CITY OF CODY
PLANNING, ZONING, AND ADJUSTMENT BOARD
TUESDAY, MAY 14, 2019
CITY HALL COUNCIL CHAMBERS @ 12:00 NOON

**CITY OF CODY
PLANNING, ZONING AND ADJUSTMENT BOARD
STAFF REPORT**

**CITY OF CODY
PLANNING, ZONING AND ADJUSTMENT BOARD
STAFF REPORT**

**CITY OF CODY
PLANNING, ZONING AND ADJUSTMENT BOARD
STAFF REPORT**

SHEET #
A1.0
MAIN FLOOR

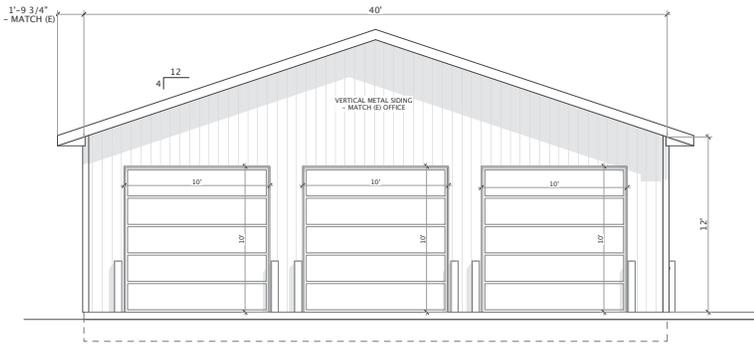
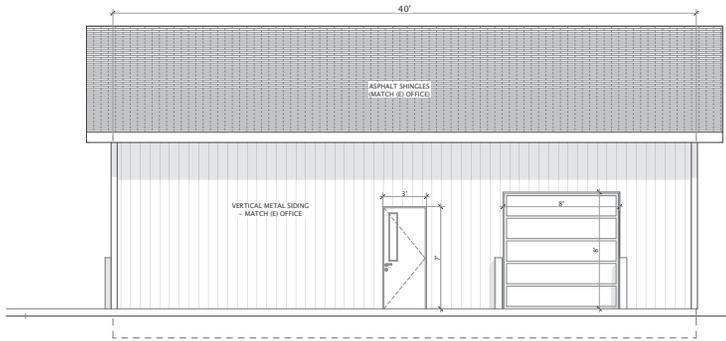
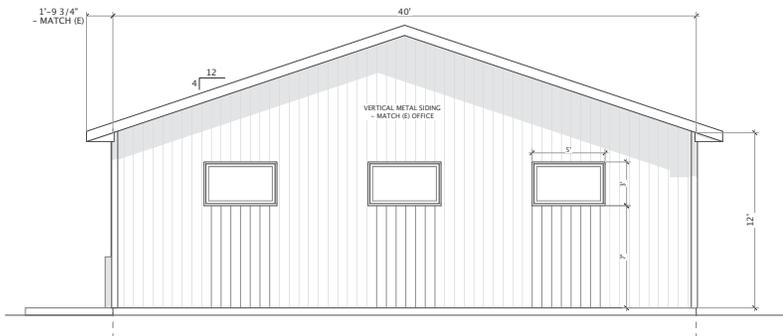
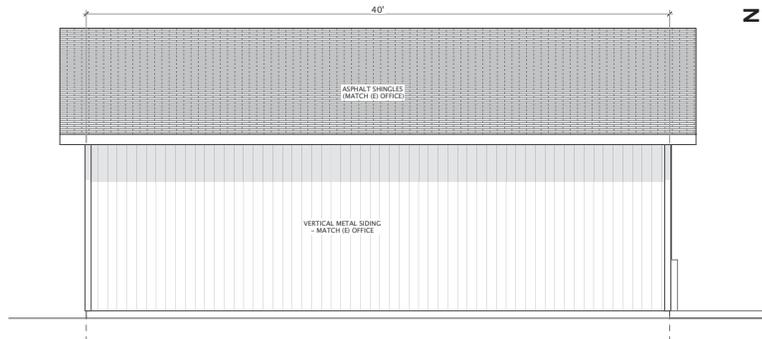
The architectural elevations of the building are found on Sheet A1.0. The storage building is designed to match the roof pitch (4:12), roof material (laminated asphalt shingles), and metal siding of the main building, which is a good design. Wall height of the storage building would be 12 feet, compared to the 15½-foot wall height on the shop portion of the main building. The storage building does not have the masonry wainscot or designer windows of the main building. Being an accessory storage building, it is not likely that the expectation is that it be equal in quality and appearance to the primary structure. That being said, as an observation, if approved as is, the building will clearly be the plainest on the street—refer to photos of surrounding area. The Board will need to determine if the architectural design of the building is compatible with the surrounding buildings in the neighborhood.

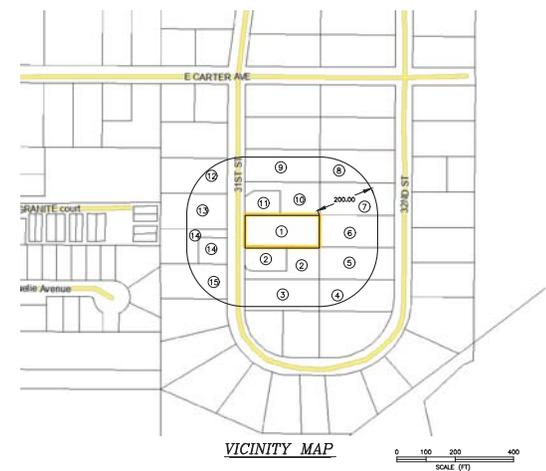
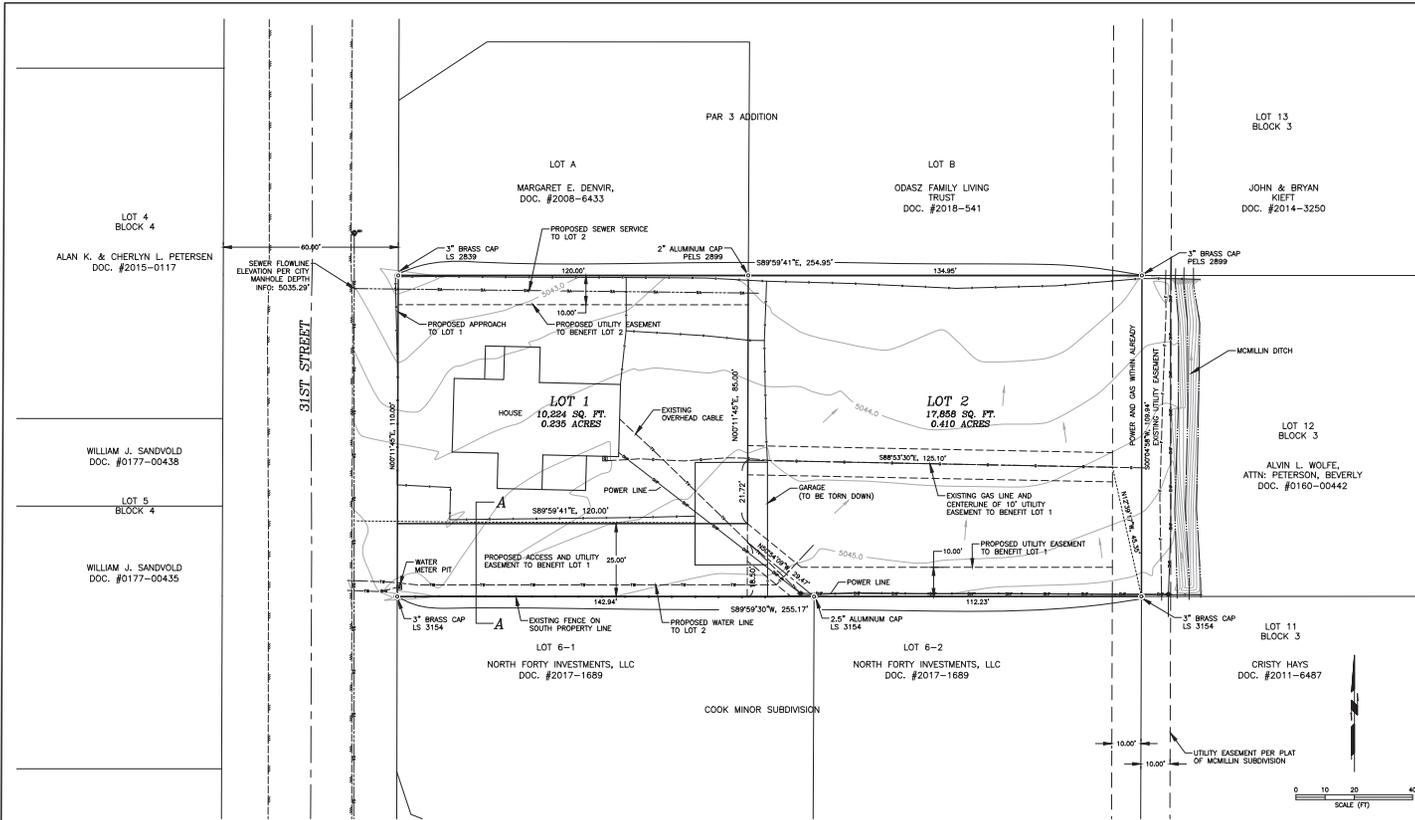
Comment: The cross section of the access drive reflects the storm water requirements, but lacks details as to rock size and depth and the need for a fabric liner under the rock.

Comment: The applicant plans to install the 6-foot solid fence, which needs to be added to the drawing.

9. Include the following construction details on the plans either by drawing or note.
 - a. The paved entrance, as noted in #3 above;
 - b. Requirements of 11-8-4(B)3.h (sewer cleanouts);

- c. Requirements of 11-8-4(B)3.i (tracer wire);
 - d. Requirements of 11-8-4(B)3.j (markers at end of service lines);
 - e. Add size and depth of rock to the swale detail, and the fabric liner;

- f. Post address for Lot 2 (1624 31st Street) at entrance; and,
 - g. Show the required 6-foot solid fence along the south side of the access easement, except the first 15 feet off of 31st Street.

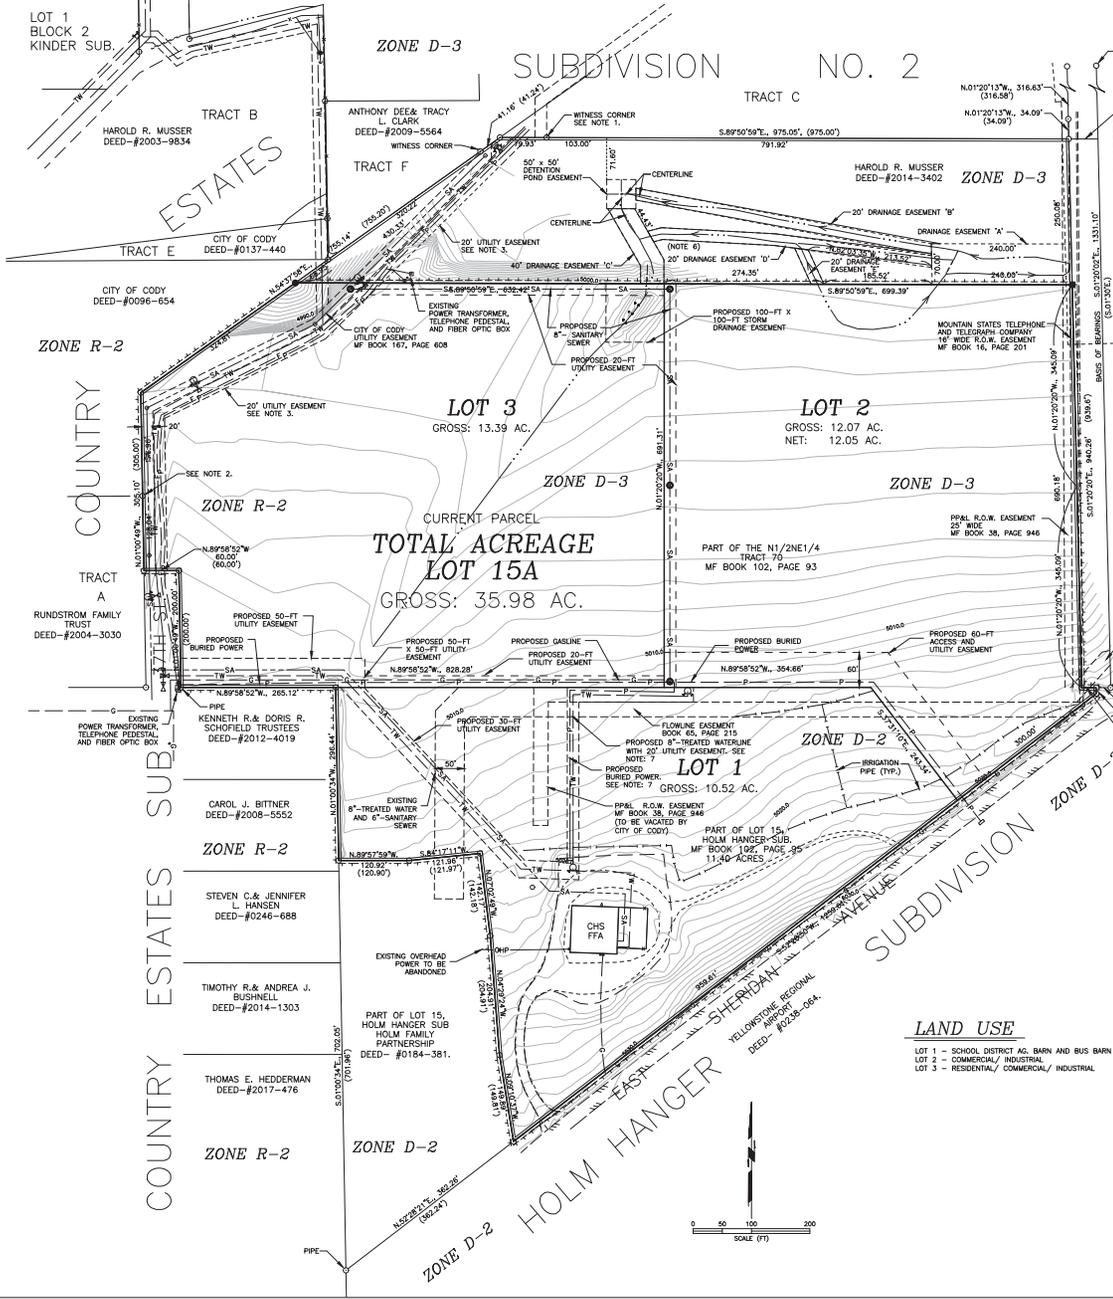
Comment: A radius will need to be added to the interior of the bend in the access easement to accommodate the radius noted.

1. Provide an updated preliminary plat with the following changes:
 - a. Note 3 references a "Parcel 2", but Parcel 2 is not identified—address as needed.

- b. The right-of-way linework in the legend is not discernable for other linework—address as needed.
 - c. Show survey markers being set at the corners of the proposed property lines.

- d. Identify the easement for the sewer mainline as a "City sewer easement", rather than a general utility easement.
 - e. The easement dimensions and descriptions for the east-west water line and accompanying utilities will need some modification, but it depends on utility placement—coordinate with Public Works.

- f. Show the electrical line extending to the SMP Pump Station service, south of East Sheridan Avenue.
 - g. Indicate the 100' by 100' drainage easement is for the benefit of Lots 2 and 3.

- h. Add a radius to accommodate a minimum 200-foot radius in the access road (NE corner of Lot 1).
 - i. Shift the access easement and property line to provide more separation from the Beacon Hill intersection, as negotiated with Public Works, but no less than 450 feet.

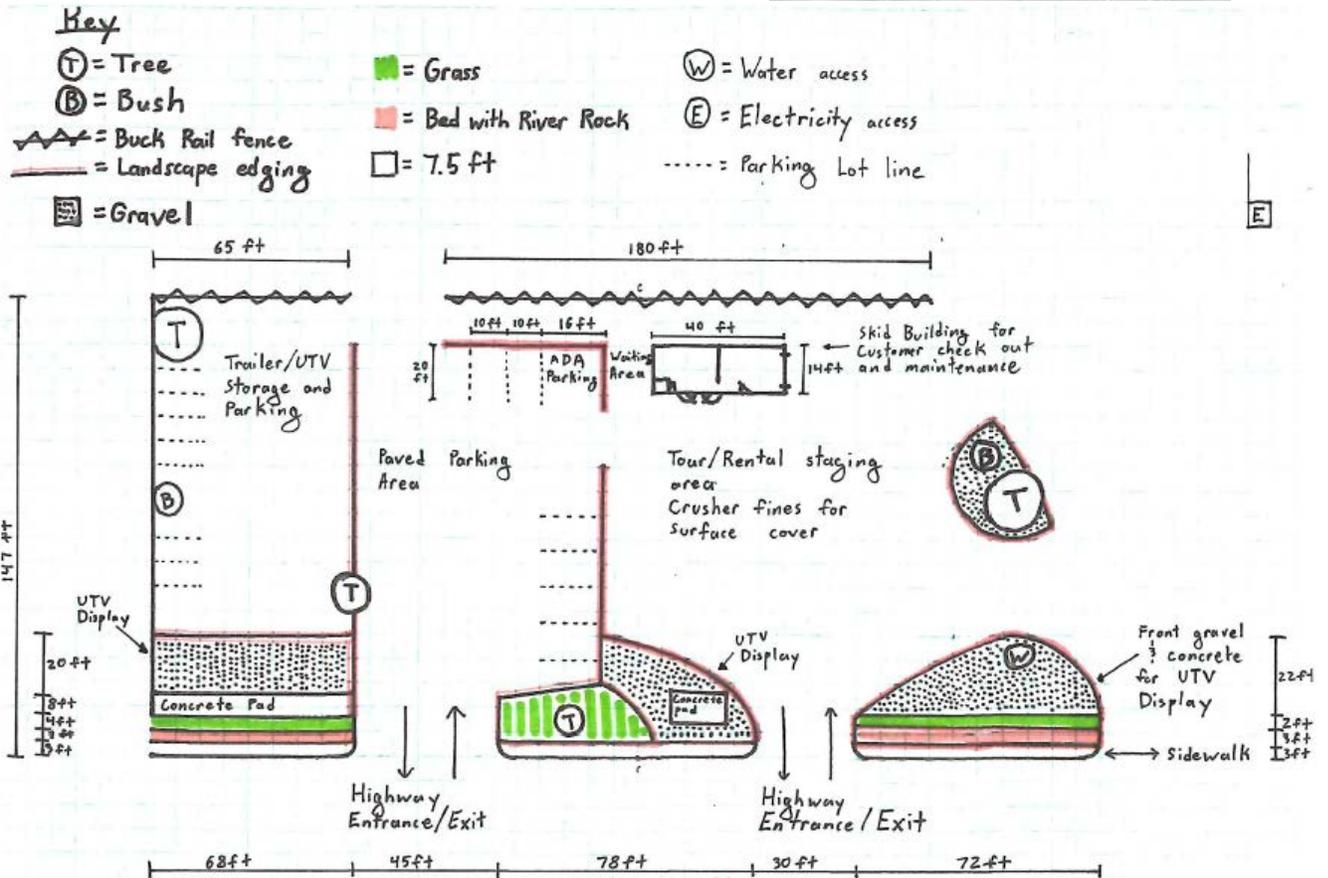
The parking plan looks acceptable, provided the ADA parking space is provided with some signage, and the stalls are either painted, or provided with wheel stops.

The site plan does not show existing property lines. Investigation has revealed that the proposed building would be over a property line if located as shown. As a result, the applicant is planning to shift the building to the west to provide the minimum 5-foot building code setback from the property line. This places the west edge of the building a couple of feet onto the paved parking pad.
